**SANTA FE COUNTY**  
**IFB 2023-0079-GM/APS**  
**GREATER GLORIETA REGIONAL WELL**

**ADDENDUM NO. 1**

**SANTA FE COUNTY**  
**IFB 2022-0234-GM/APS**  
**GREATER GLORIETA REGIONAL WELL**

**ADDENDUM NO. 2**

#### **Contract Drawings:**

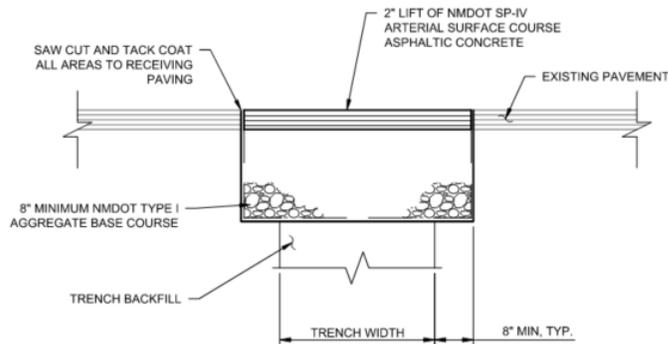
- 1. Sheet G-01:**
  - **Delete G-00 in the INDEX OF SHEETS**
- 2. Sheets C-01 through C-03**
  - **Station 71+60.4 to Station 119+20: Change all 8” diameter piping waterline and fittings to 6” PVC to 6” diameter PVC.**

- 3. Sheet G-01**
  - **Add the following Note 12 to GENERAL CONSTRUCTION NOTES:  
GENERAL CONSTRUCTION NOTE 12. CONTRACTOR SHALL INSTALL ALL WATER UTILITY INFRASTRUCTURE IN ACCORDANCE WITH THE MOST CURRENT EDITION OF THE SANTA FE COUNTY WATER UTILITIES WATER AND SEWER CONSTRUCTION STANDARDS AND SPECIFICATIONS. IF THERE IS A CONFLICT BETWEEN ANY CONTRACT PLANS AND SPECIFICATIONS, THE STRICTER REQUIREMENT SHALL APPLY.**

- 4. Sheet G-02**
  - **Add the following Note 9 to the WATER SYSTEM NOTES:  
WATER SYSTEM NOTE 9. CONTRACTOR SHALL COMPLETE A FLOW TEST ON ALL FIRE HYDRANTS AND COLOR CODE THE HYDRANTS IN ACCORDANCE WITH SANTA FE COUNTY UTILITY STANDARDS.**

- 5. Sheet G-06, SERVICE CONNECTION DETAIL B**
  - **Add a CONSTRUCTION NOTE M to read as follows:  
CONTRACTOR SHALL INSTALL IN-LINE BRASS BALL VALVE WITH LOCKABLE TEE-HEAD STEM AND VALVE CAN DOWNSTREAM OF ALL WATER SERVICE METERS IN ACCORDANCE WITH SANTA FE COUNTY UTILITLY STANDARDS. VALVE SIZE TO MATCH SIZE OF SERVICE LINE. CONTRACTOR TO COORDINATE WITH GLORIETA ASSOCIATION OPERATOR REGARDING FINAL LOCATION OF IN-LINE VALVE AND RELOCATED METERS.**
